Access Compliance Report

Public Rights-of-Way

(Curb Ramps)

Intersection ID: 52442	Main Street: WOODWARD_AV	Cross Street: BENDING_BIRCH_PL	Location: SW
ADA ID: 2EE14052E679	Ramp Type: Directional1	Initial Pass/Fail: Fail	Overall Compliance: No
Codes/Mitigation Info/Possible Solution		Field Measurements/Component Compliance	
Severity Score: 13.75

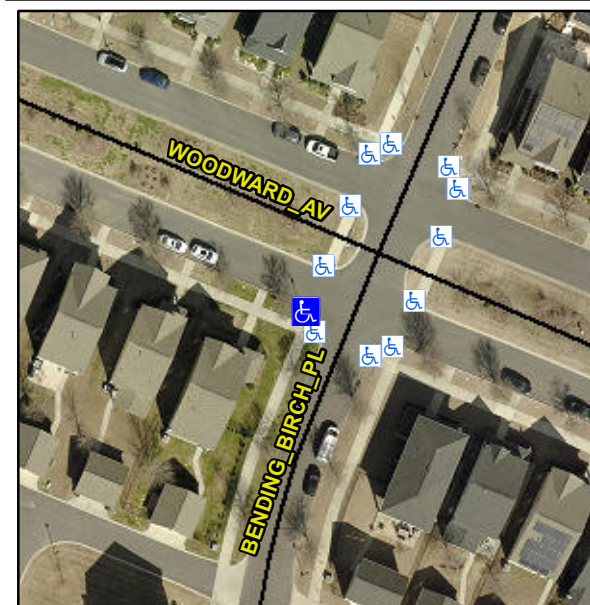
R304.2.2

Compliance	Description	Data	Compliance	Description	Data
N/A	Ramp Length (in)	79.0	N/A	Grade Break?	N/A
Yes	Ramp Width (in)	60.0	N/A	Grade Break Slope (%)	0.0
No	Ramp Slope (%)	9.1	N/A	Grade Break XSlope (%)	0.0
Yes	Ramp XSlope (%)	2.8			
N/A	Flare Type LT	N/A	N/A	Flare Type RT	N/A
N/A	Flare Slope LT (%)	N/A	N/A	Flare Slope RT (%)	0.0
N/A	Flare Traversable LT?	N/A	N/A	Flare Traversable RT?	N/A
N/A	Landing Length (in)	0.0	N/A	DWS Provided?	N/A
N/A	Landing Width (in)	0.0	N/A	DWS Contrast?	N/A
N/A	Landing Slope (%)	0.0	N/A	DWS Length (in)	N/A
N/A	Landing X Slope (%)	0.0	N/A	DWS Full Width?	N/A
N/A	Landing Curb? (Y/N)	N/A	N/A	DWS Offset LT (in)	N/A
N/A	Shared Landing?	N/A	N/A	DWS Offset RT (in)	N/A
N/A	Gutter Ponding?	0.0	N/A	Gutter Slope (%)	N/A
N/A	Gutter Lip Ht (in)	2.0	N/A	Gutter X Slope (%)	N/A
N/A	Painted X Walk1?	No		Road Slope (%)	2.9
	X Walk 1 Direction	To N		Road X Slope (%)	6.1
	X Walk 1 Width (in)	N/A		Clear Space?	N/A

Remove & Replace Entire Ramp.
